***KING'S MARK
ENVIRONMENTAL REVIEW TEAM
REPORT***

**MUNICIPAL
INDUSTRIAL PARK**

Environmental Review Team Report

January 1995

PROPERTY OUTLINE MAP

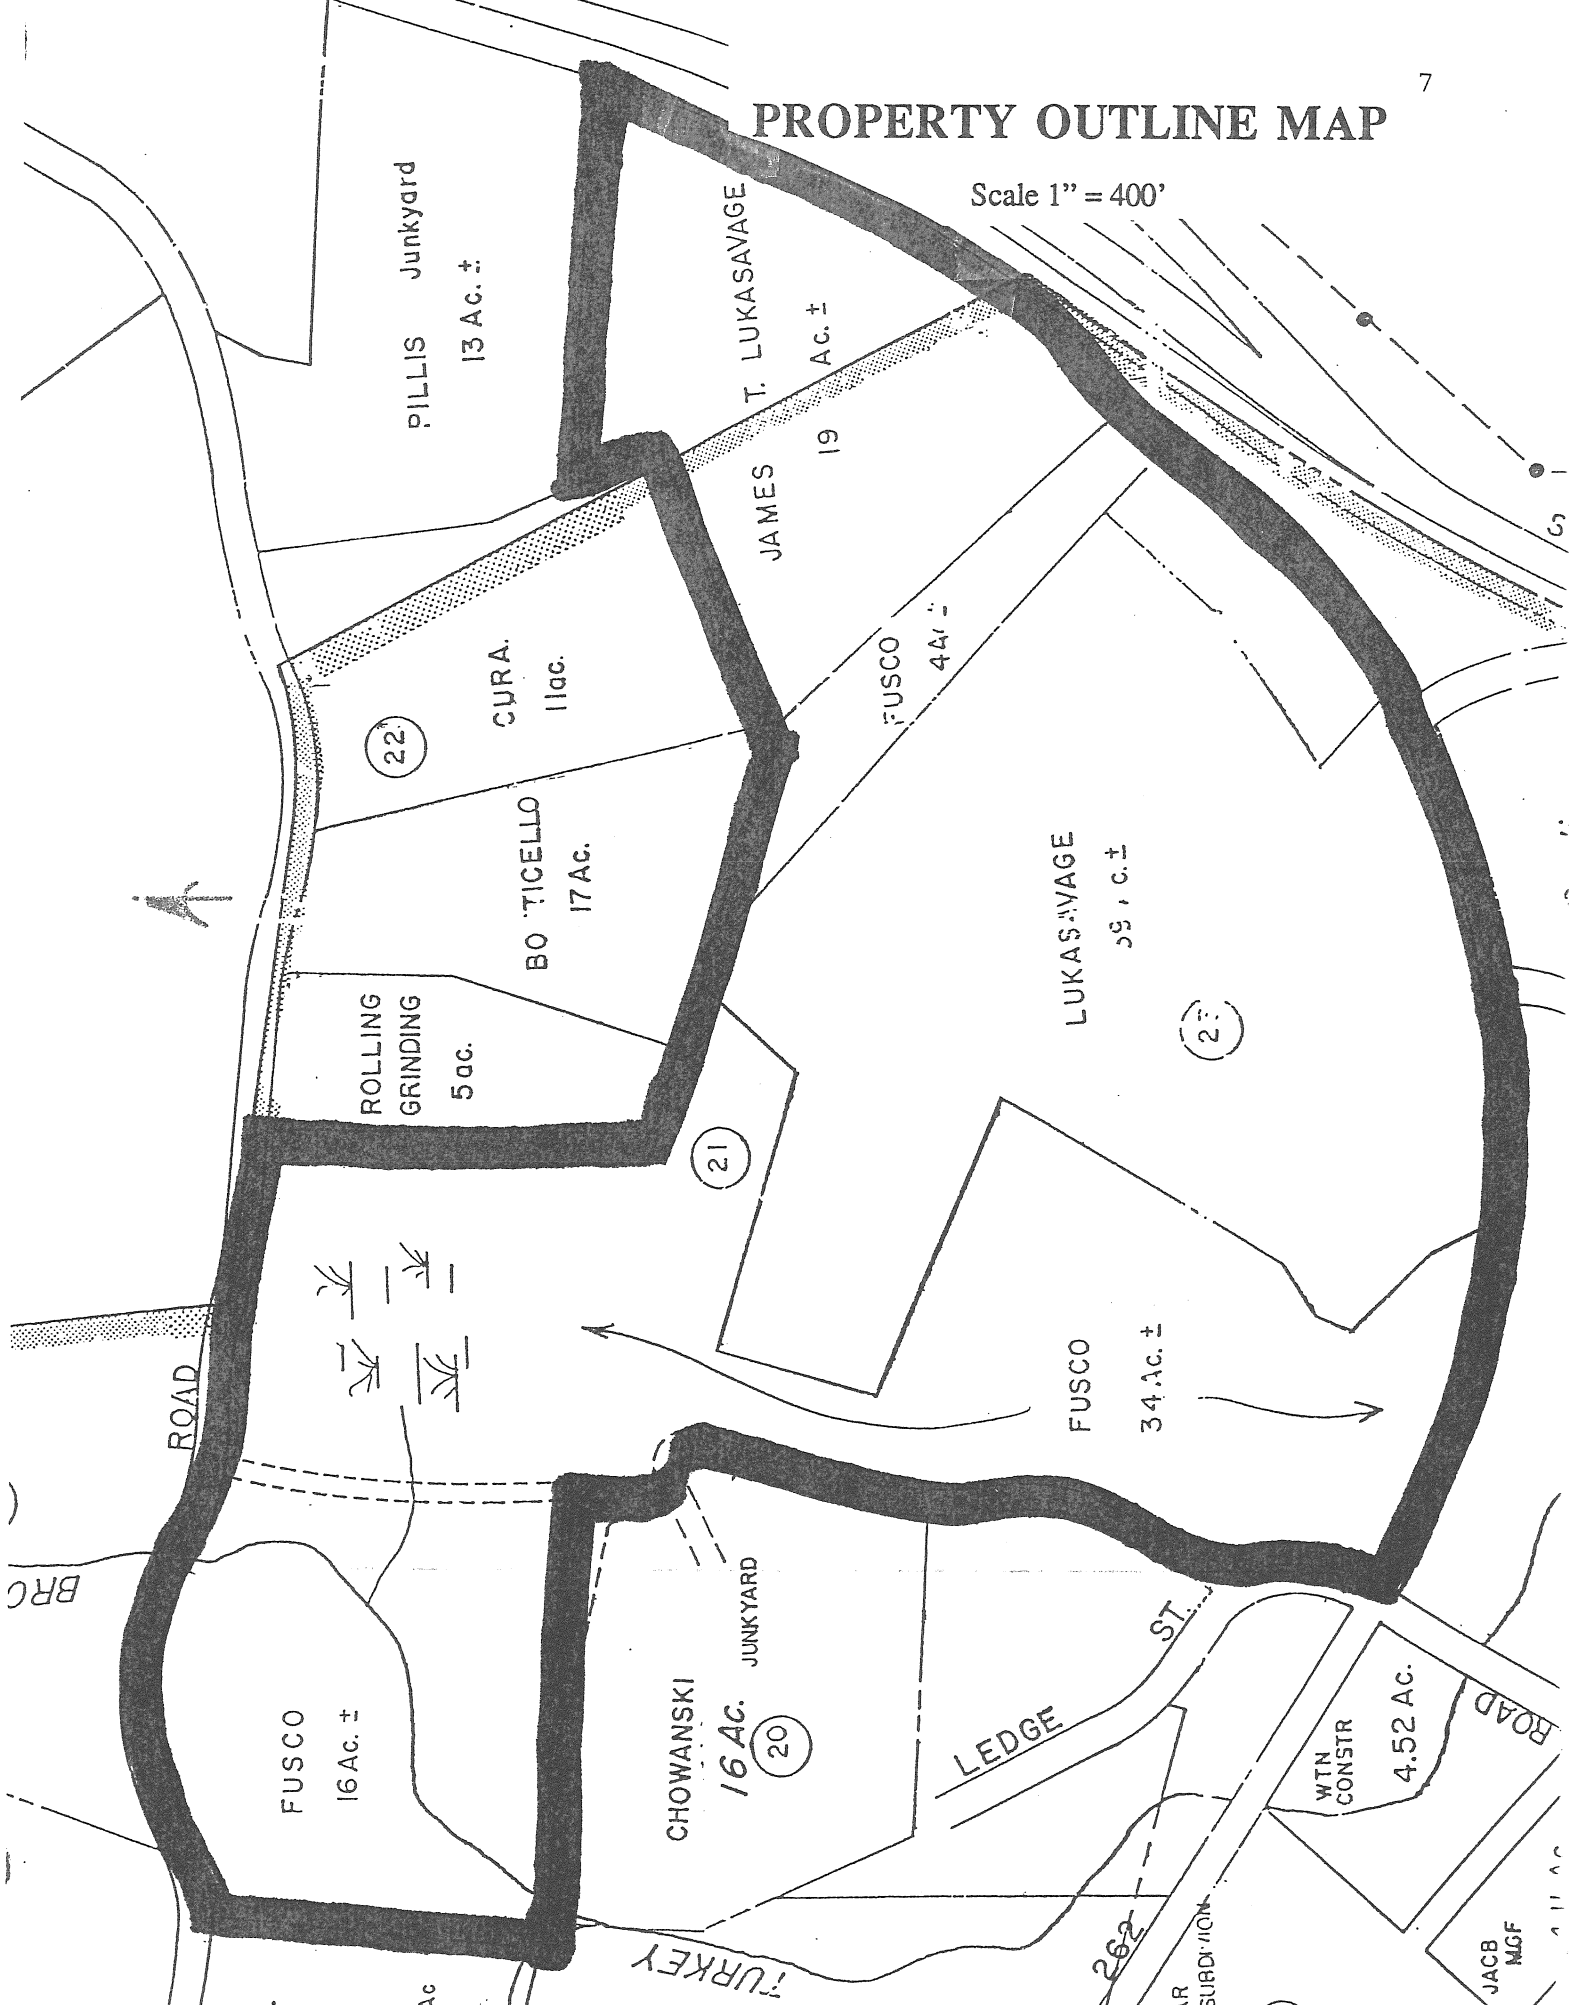
Road "A" on the proposed layout is shown to be very close to or within a wetland boundary, by moving it eastward toward Lot #47, it may be out of the wetland boundary. Lot #49 appears to contain

a major portion of wetland soil types so that it may not have enough room for a building and parking area without disturbing wetlands.

2) Re-route Road "A" north of its intersection with Road "B" to avoid wetland impacts to wetland #1. Commit lots #45, #46 and #49 to open space to protect the integrity of wetland #1.

6) Maintain drainage through lots #13, #8 and #7 which most likely contribute flow to wetland #2.

WETLANDS MAP

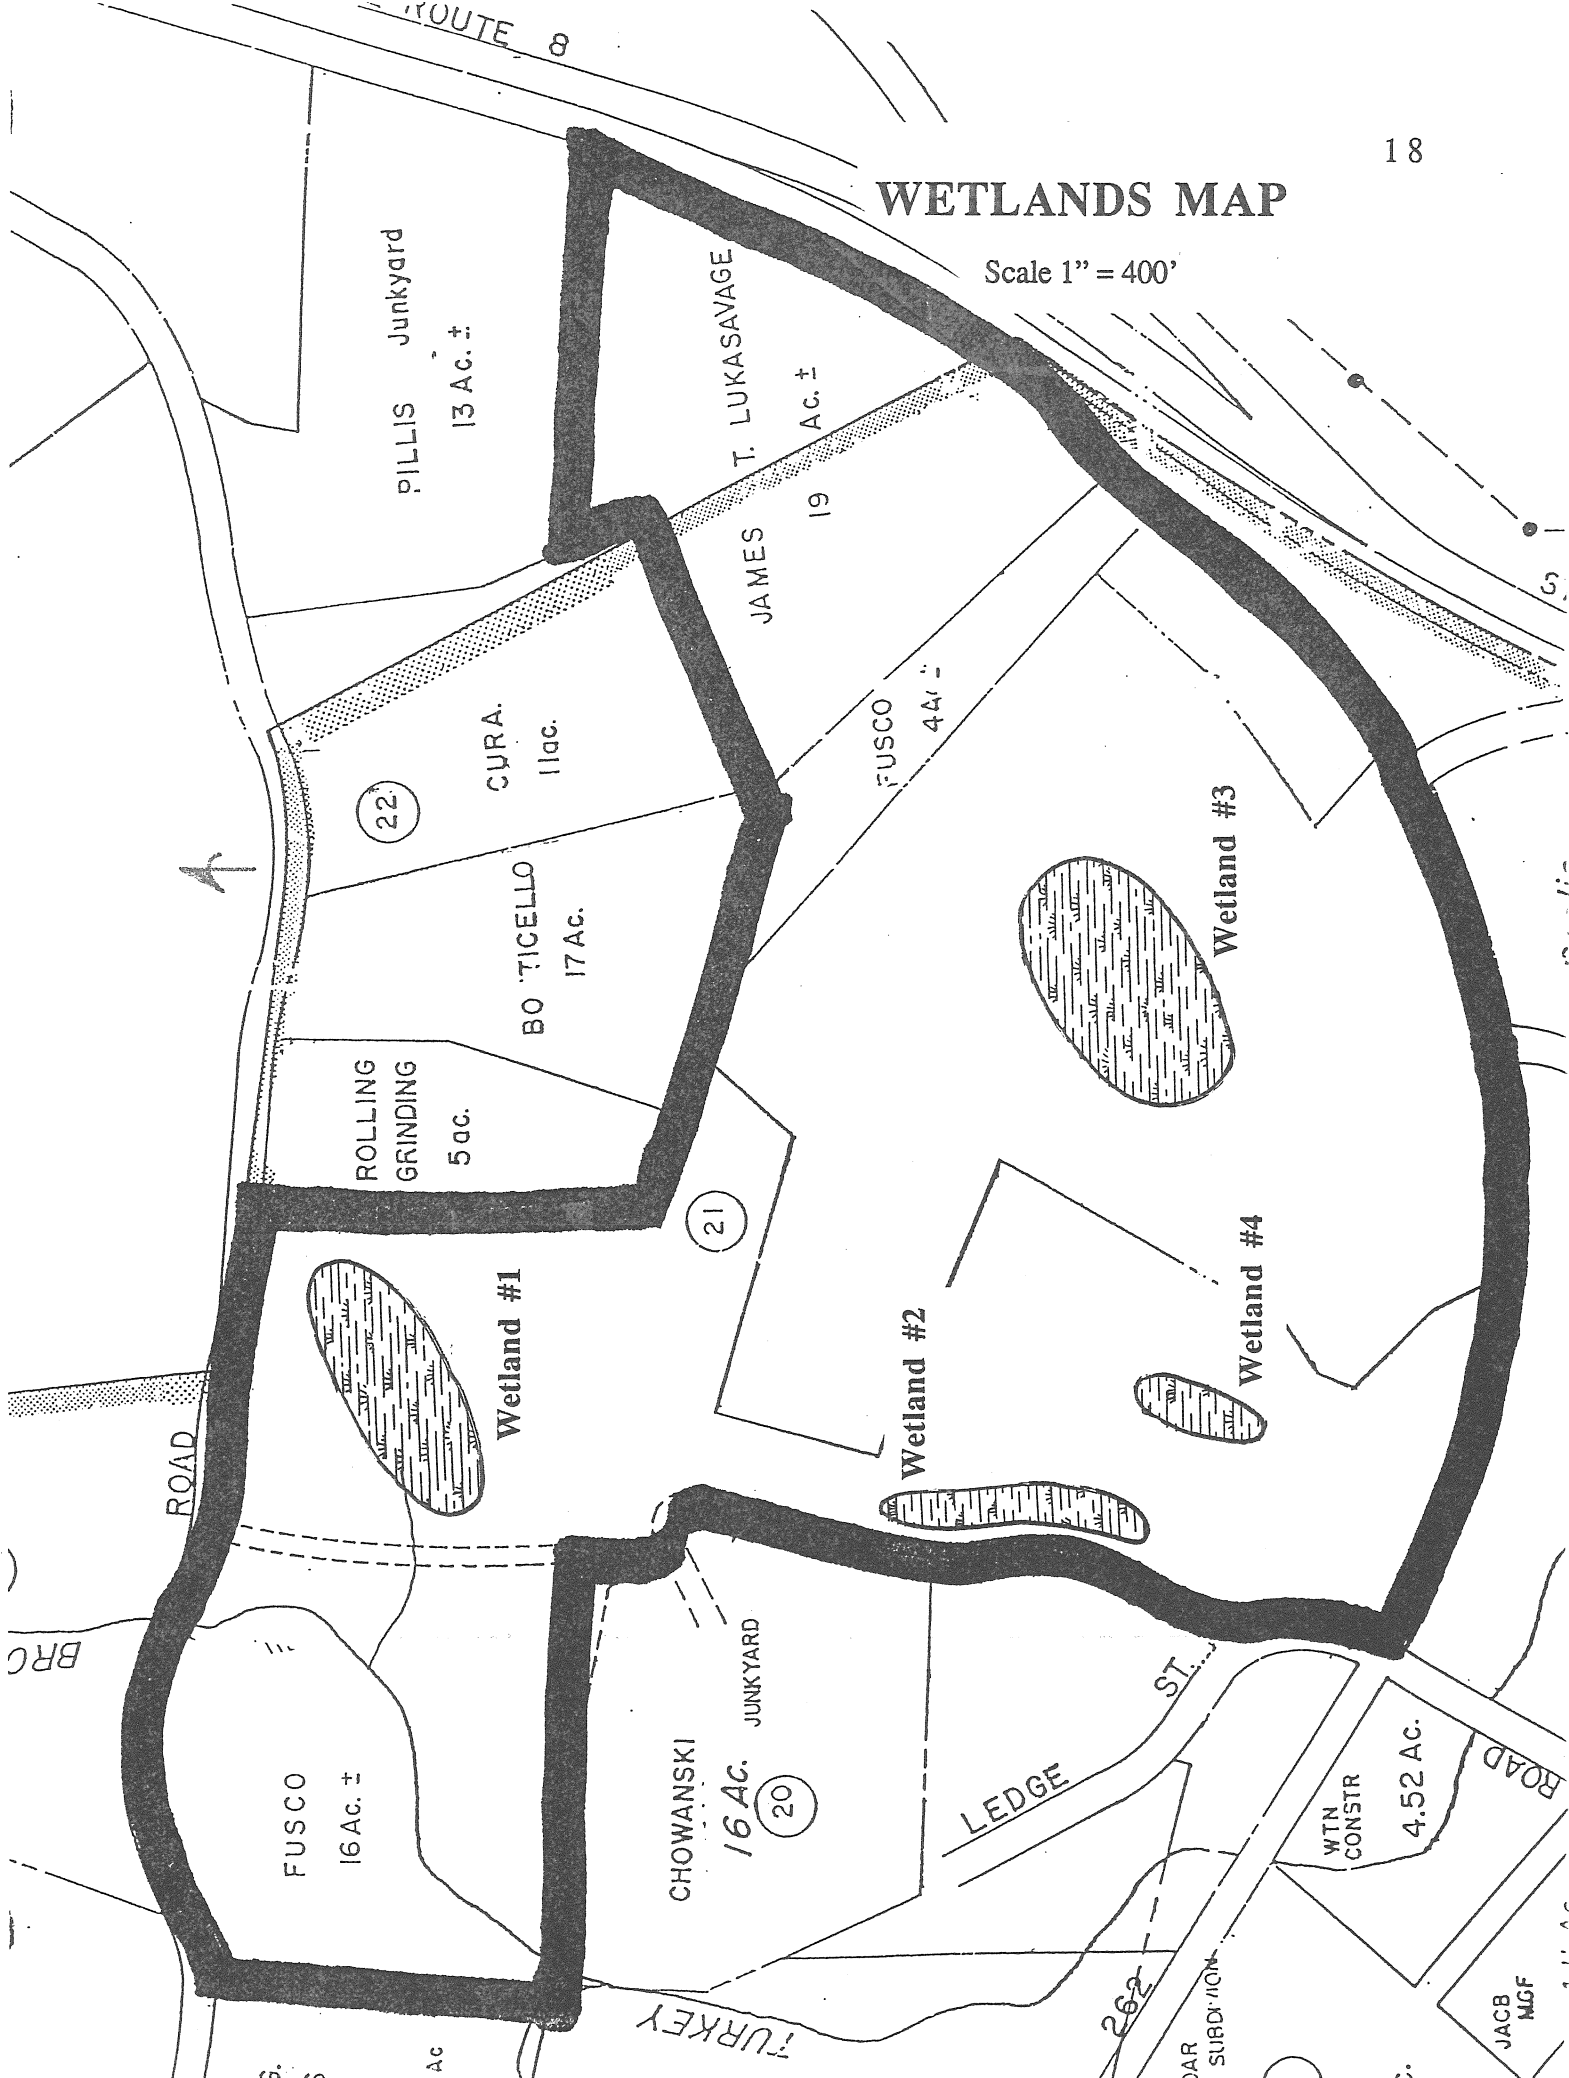
- 1) Determine the existence of existing wetland delineation maps drafted as a result of previous development proposals. If the delineation was performed by a certified soil scientist and a record of that delineation was properly acquired by the Town of Watertown, this information would provide the most complete and accurate record of inland wetland soils throughout all or most of the study site. It may also provide more accurate topography.
- 2) Re-route Road "A" north of its intersection with Road "B" to avoid the direct impacts made upon wetland #1 discussed earlier. Follow the contour to the northeast and connect with Echo Lake Road approximately 500, to the east of the proposed intersection. Commit lots #45, #46 and #49 to open space use to protect the integrity of wetland #1.
- 3) Direct impacts to wetland #2 may be unavoidable due to space limitations, however, removal and

5) If this project will impact more than 1 acre of wetlands, it will require an Individual Permit from the U.S. Army Corp of Engineers (A.C.O.E.) and a Water Quality Certification (WQC) from CT DEP. If this project will impact only .5 to 1 acre of wetlands, a WQC must be obtained from CT DEP. For questions regarding these regulatory programs contact Ruth Ladd of the A.C.O.E. at 617/647-8338 or 800-343-4789 or Sally Snyder of the CT DEP at 203/424-3019.

7) Due to their flood control and wildlife values, strive to maintain an adequate upland buffer area around all wetland areas as well as Turkey Brook. A distance of at least 50 feet and preferably 100 feet is recommended. It would also be worthwhile to create a conservation easement along Turkey Brook to permanently preserve any wildlife corridor attributes in conjunction with Mattatuck State Forest.

8) Due to the location within the watershed, it may be wise to maintain a 0% increase in storm water run-off emanating from this site. This may avoid aggravating or creating flood-prone areas downstream of the study area. It may also avoid channel erosion which usually accompanies increased channel flows. This approach should ultimately be confirmed through a detailed hydrology/hydraulics study of pre- and post-development conditions as well as downstream hydrology studies. Any required storm water detention/retention basins should be located outside of existing wetland areas. Requiring a certain amount of non-pervious open space on each lot would allow for storm water infiltration to take place throughout the study area. Natural, non-landscaped open space would allow
